BYLONG COAL PROJECT

Environmental Impact Statement Response to Submissions

BYLONG COAL PROJECT

RESPONSE TO SUBMISSIONS

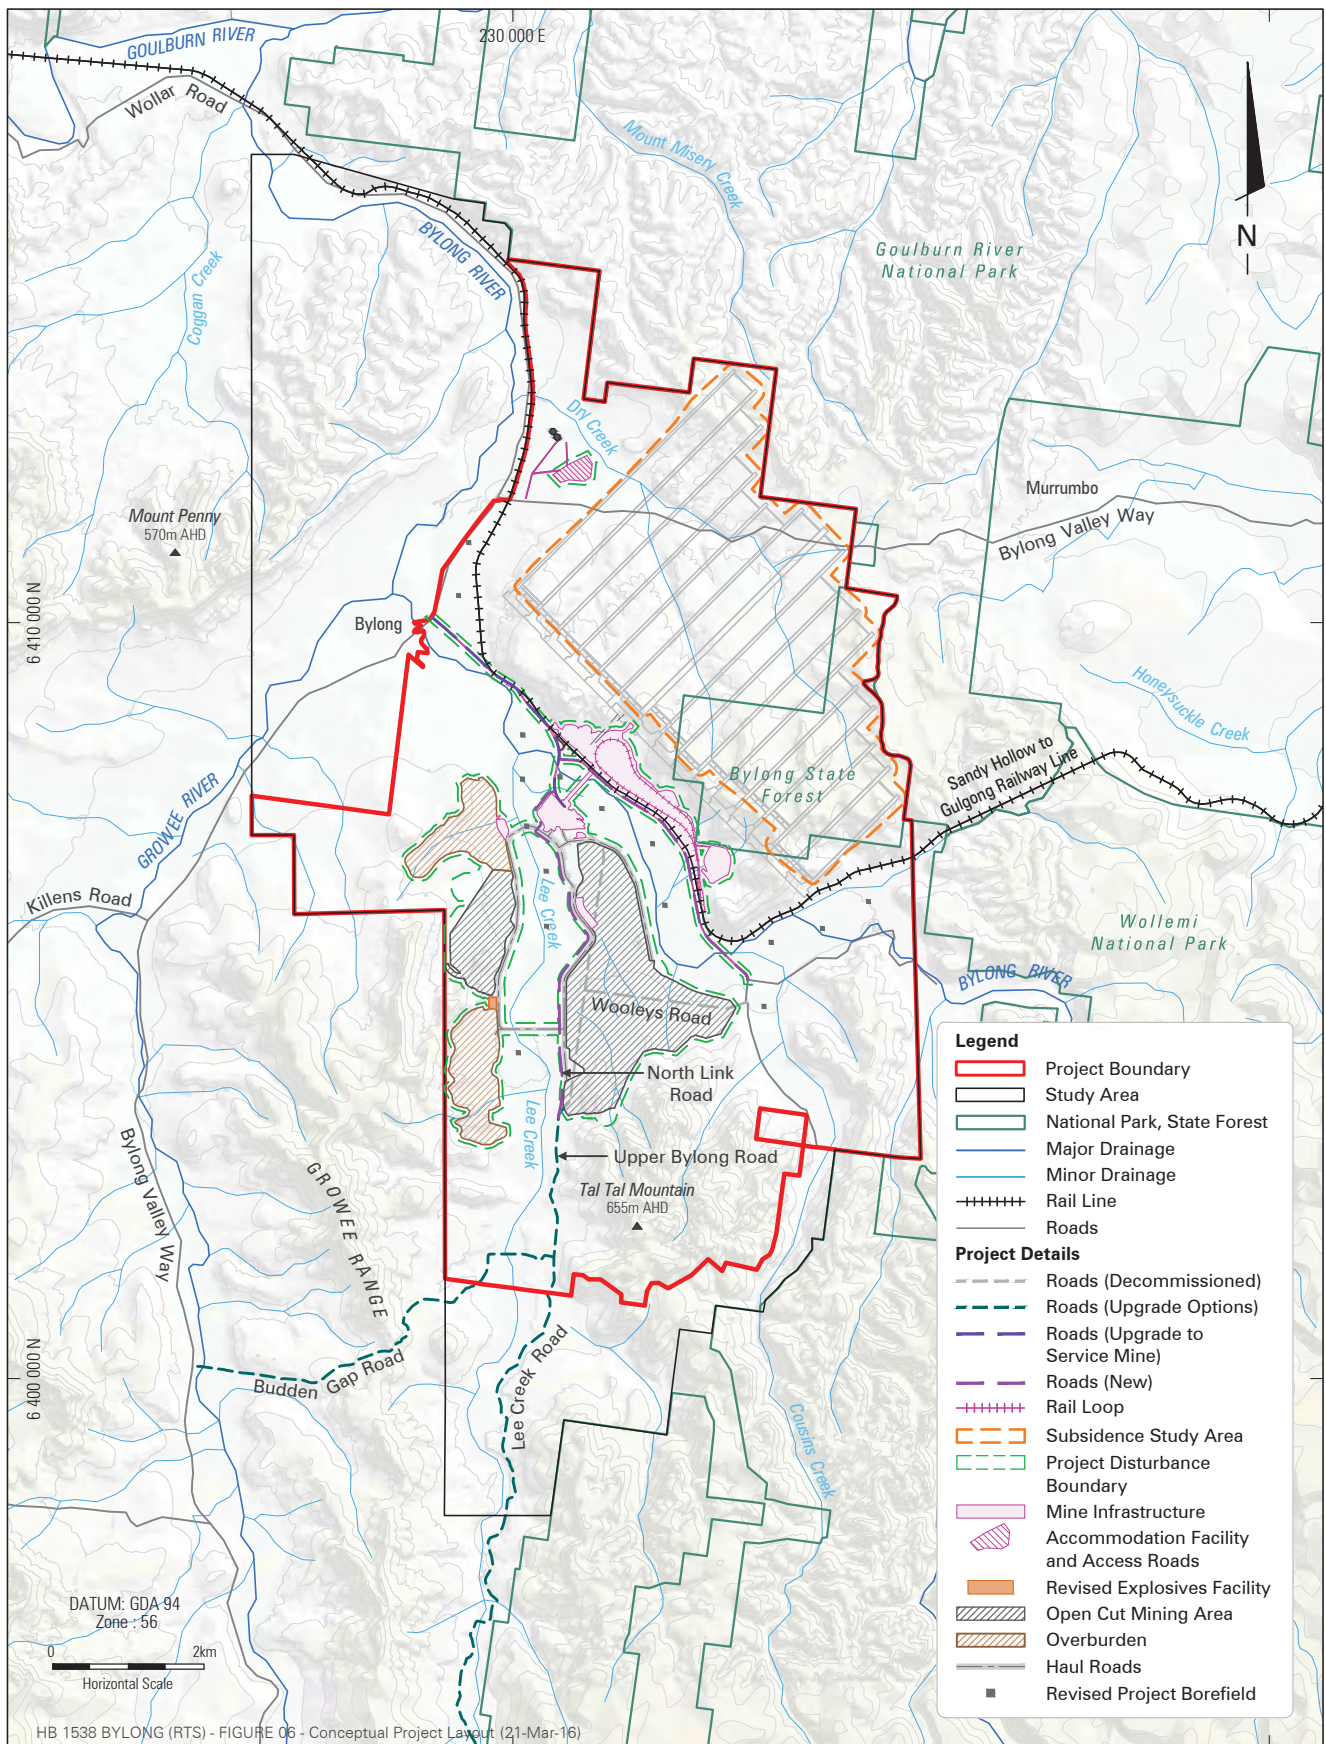
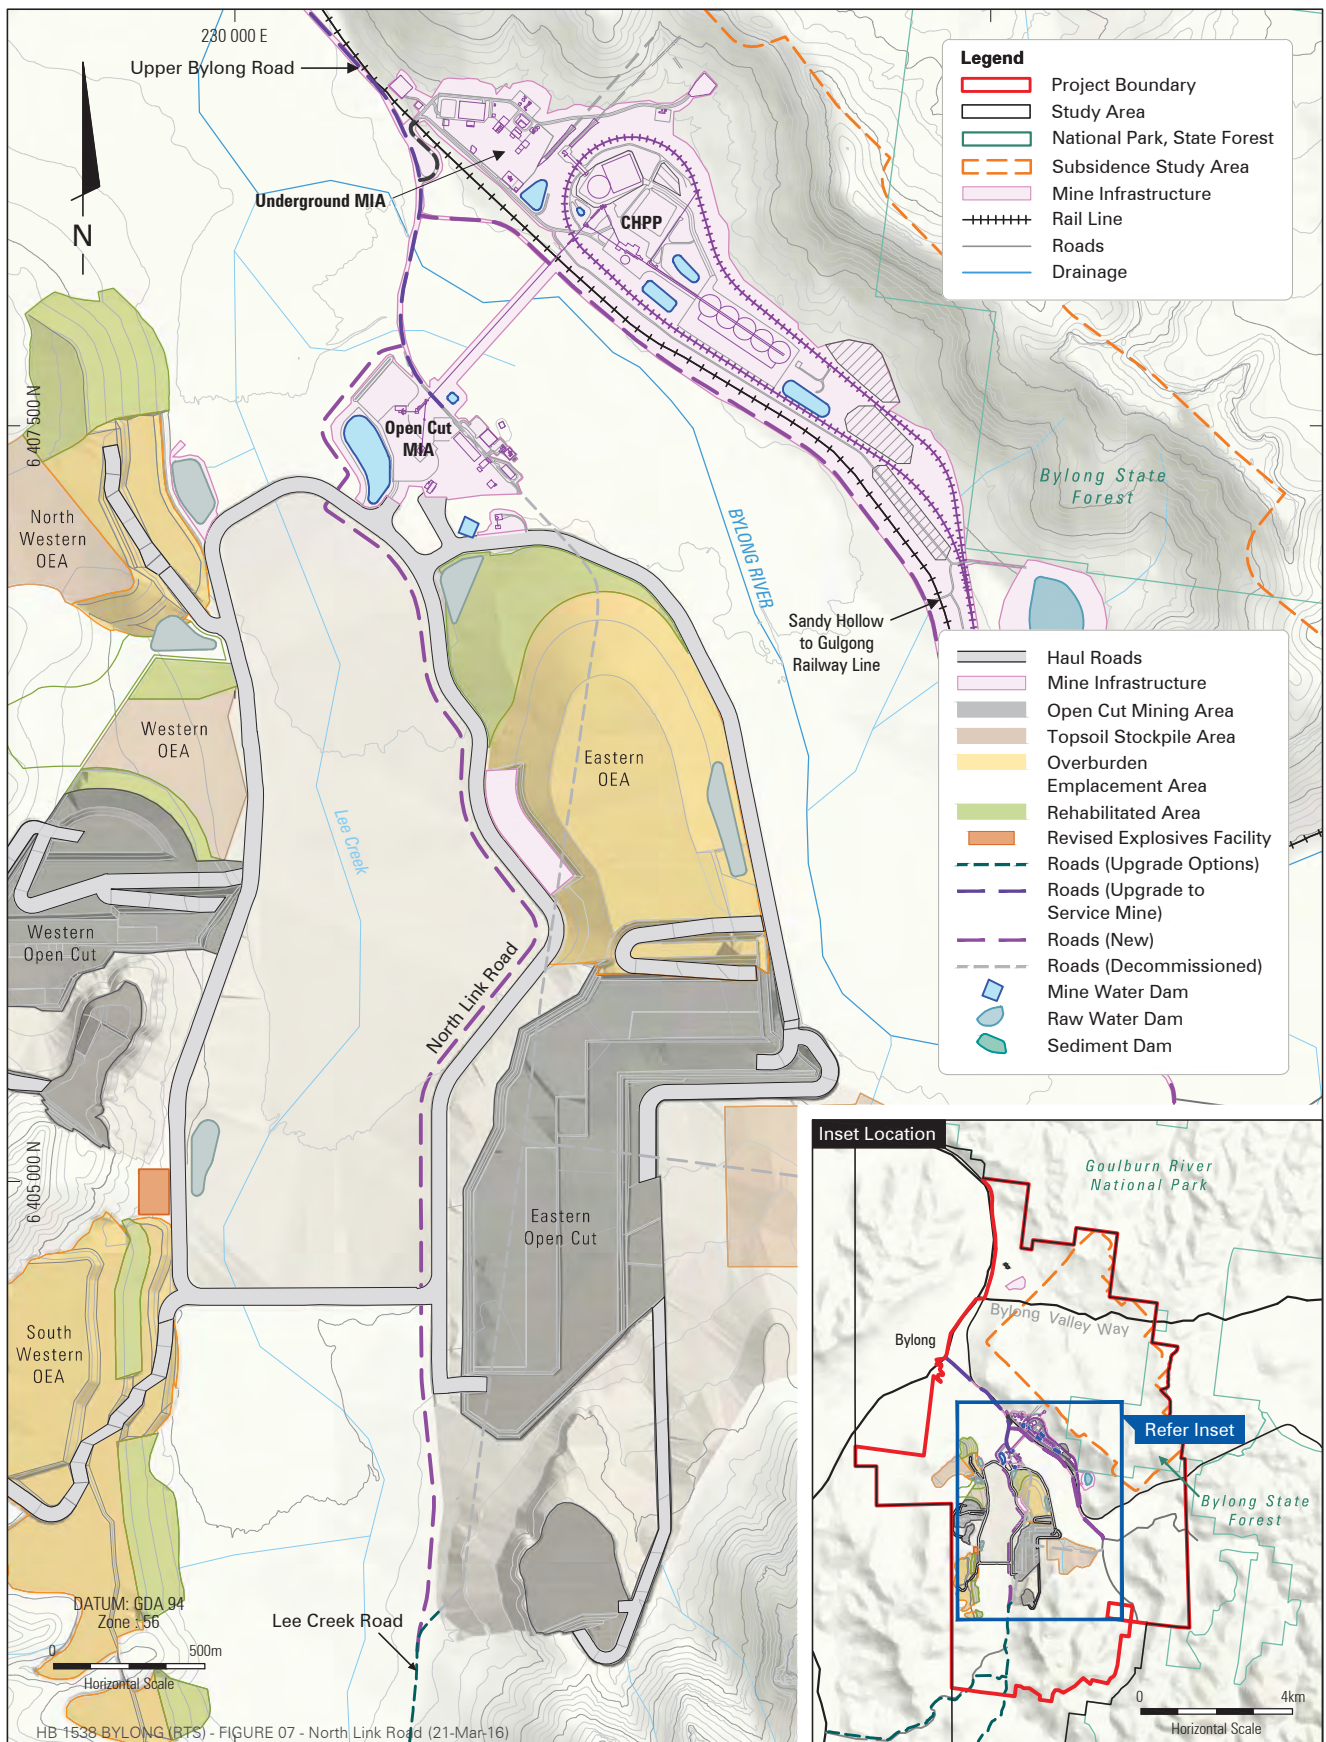
The report identifies two alternative routes for landholders located to the south of the project area to utilise when the Upper Bylong Road is re-aligned resulting in the isolation of private holding to the south of the lease area. These are the Budden Gap and Lee Creek Roads. Whilst neither route is ideal for the affected parties, the latter is Council's preferred option as the road is already formed and traverses comparatively moderate terrain. The Lee Creek Road alternative is a considerably simpler road to upgrade from a constructability point of view. The access for the affected landholders should be negotiated prior to any approval being issued for the project.

Since the lodgement of the EIS, KEPCO has developed a third option to provide alternate access for landholders located to the south of the Project. This option is the preferred option and comprises the construction of a new road named the North Link Road. KEPCO seeks approval for the construction and operation of this new road as part of the Project.

The North Link Road alignment will follow the western limit of the Eastern Overburden Emplacement Area (OEA) and Open Cut Mine Infrastructure Area (MIA) before joining the existing Upper Bylong Road to the north of the Open Cut MIA as conceptually illustrated on **Figure 6** and **Figure 7**. The North Link Road is proposed to be constructed entirely within the Project Disturbance Boundary assessed within the EIS.

FIGURE 18

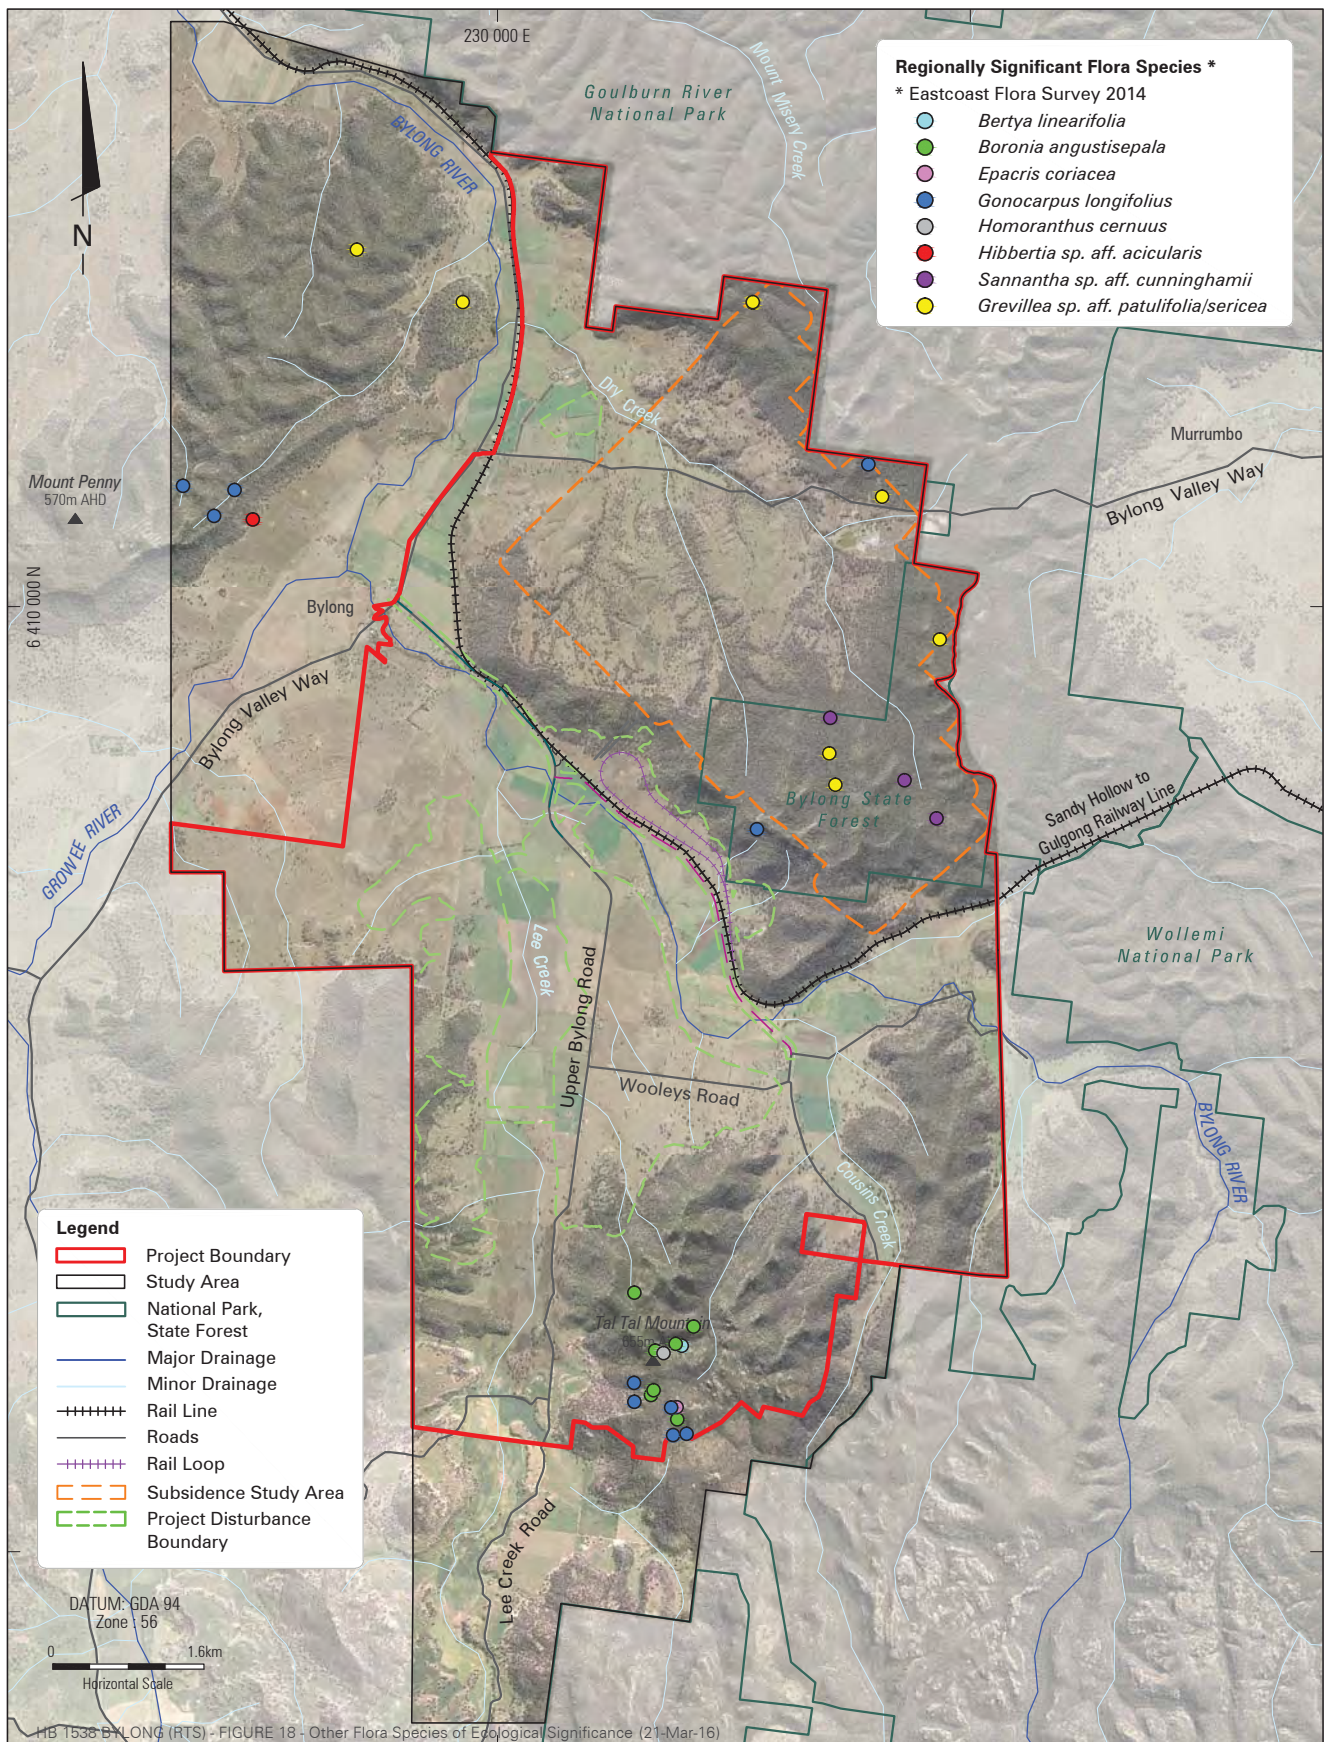
The EIS lists three species found within the study area which may represent new taxonomic entities, Hibbertia sp. aff. acicularis, Sannantha sp. aff. cunninghamii and Grevillea sp. aff. patulifolia/sericea. Only very general information regarding their location is given in Appendix J. OEHL requires the locality information of these taxa to ensure they will not be affected by the proposed development.

11.1 KEPCO supplies OEHL with location details of the three potentially new flora taxa.

The locations of the three potential new species are shown in Figure 3.9 of the EIS Ecological Impact Assessment, and reproduced in **Figure 18**. **Table 18** lists the vegetation communities in which the species were recorded in. None of the recorded individuals of the potential new species occur within the Project Disturbance Boundary and will not be directly impacted by the Project. Of the 12 individuals of the potential new species, nine occur within the Subsidence Study Area, which may be subject to subsidence-related impacts, this includes six individuals of *Grevillea sp. aff. patulifolia/sericea* and three individuals of *Sannantha sp. aff. cunninghamii*.

HB 1538 BYLONG (RTS) - FIGURE 19 - Revised Post-mining Land Use (21-Mar-16)

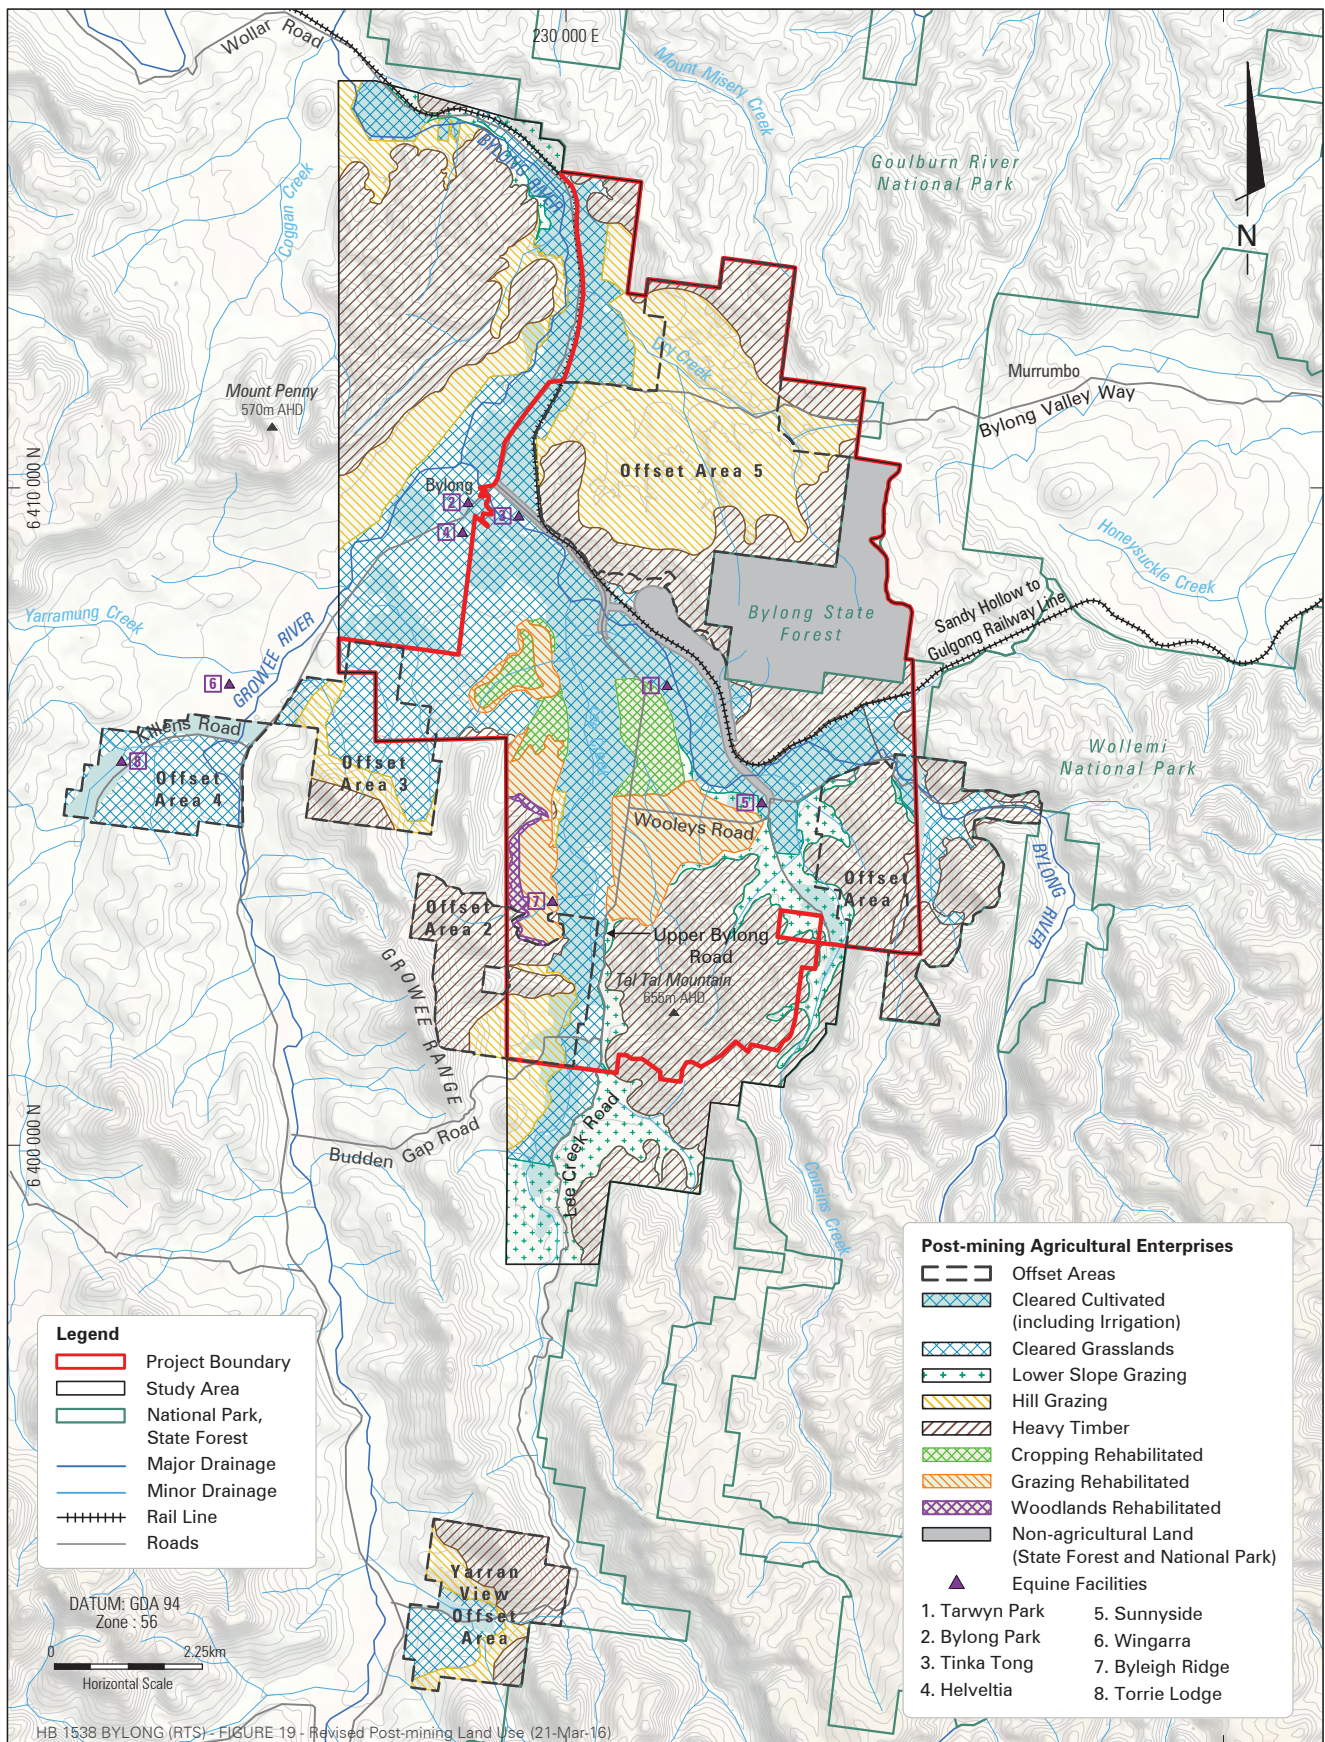
Figure 62 Post-mining Land Use has mapped the following areas as cleared grasslands which should have been mapped as heavy timber:

- *a large area centred on Tal Tal Mountain,*
- *western half of Offset Area 1, and*
- *a small area just to the north of the project boundary.*

KEPCO will apply to the EPA at the appropriate time to obtain an EPL and Radiation Management Licence. A copy of the Post-Mining Land Use Figure (Figure 62 of the EIS) has been revised and is included in this RTS as **Figure 19**.
